Project	IEEE 802.16 Broadband Wireless Access Working Group < http://ieee802.org/16 >	
Title	Text Amendment for Draft 802.16m Evaluation Methodology: 5.1.2 Dynamic PHY Abstraction Methodology	
Date Submitted	2007-5-3	
Source(s)	Shiang-Jiun Lin, I-Kang Fu, Chi-Fang Li, Ting-Chen Song, Wern-Ho Sheen NCTU/ITRI 1001 Ta Hsueh Road, Hsinchu, Taiwan 300, ROC.	hjlin@itri.org.tw IKFu@itri.org.tw richard929@itri.org.tw tomtom@itri.org.tw whsheen@itri.org.tw
Re:	IEEE 802.16m-07/014r1, "Call for Comments on Draft 802.16m Evaluation Methodology Document"	
Abstract	This contribution provides the text amendment and additional figure to the section '5.1.2 Dynamic PHY Abstraction Methodology' for improving the description.	
Purpose	Propose the MI based link quality model for 16m Evaluation Methodology	
Notice	This document has been prepared to assist IEEE 802.16. It is offered as a basis for discussion and is not binding on the contributing individual(s) or organization(s). The material in this document is subject to change in form and content after further study. The contributor(s) reserve(s) the right to add, amend or withdraw material contained herein.

Text Amendment for Draft 802.16m Evaluatio

[Figure x: Link-to-system mapping procedure](#)

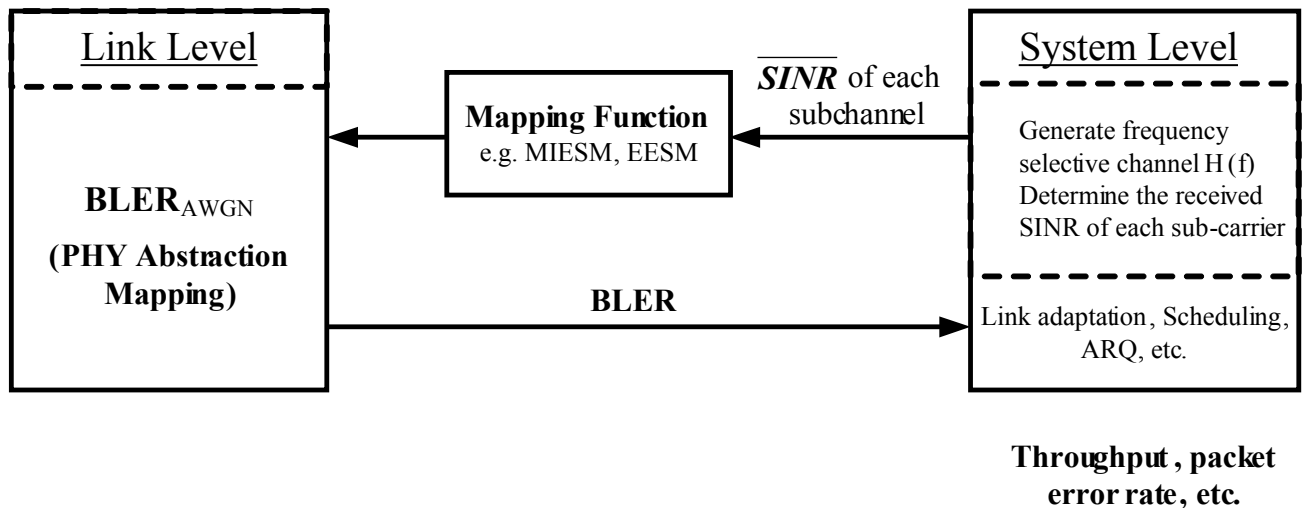
[Add the following text and figure after the line#35 of the page#38 in C802.16m-07/080r1]

Figure y: The computational procedure of MIESM

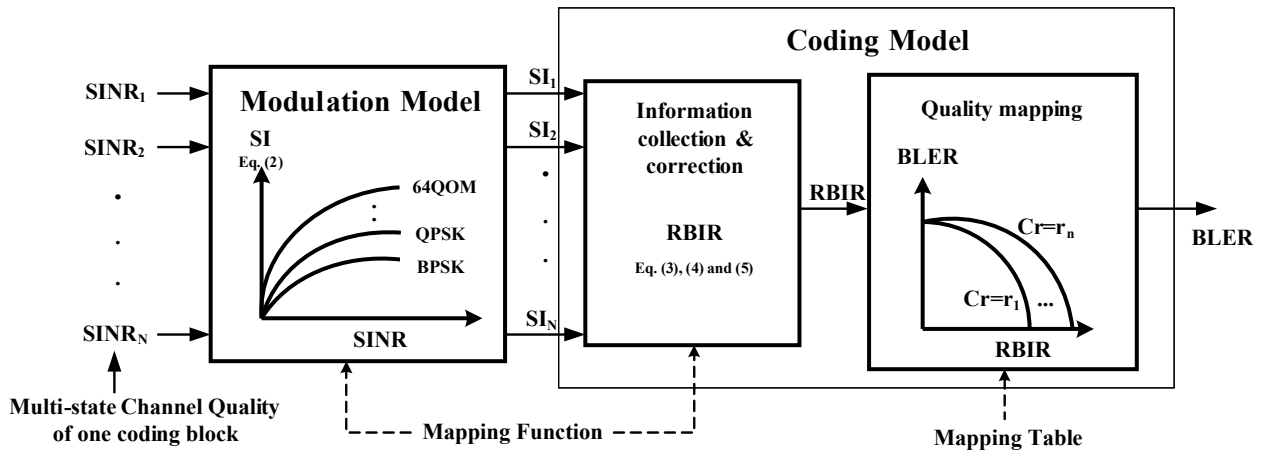
[Add the following text and figure after the line#13 of the page#40 in C802.16m-07/080r1]
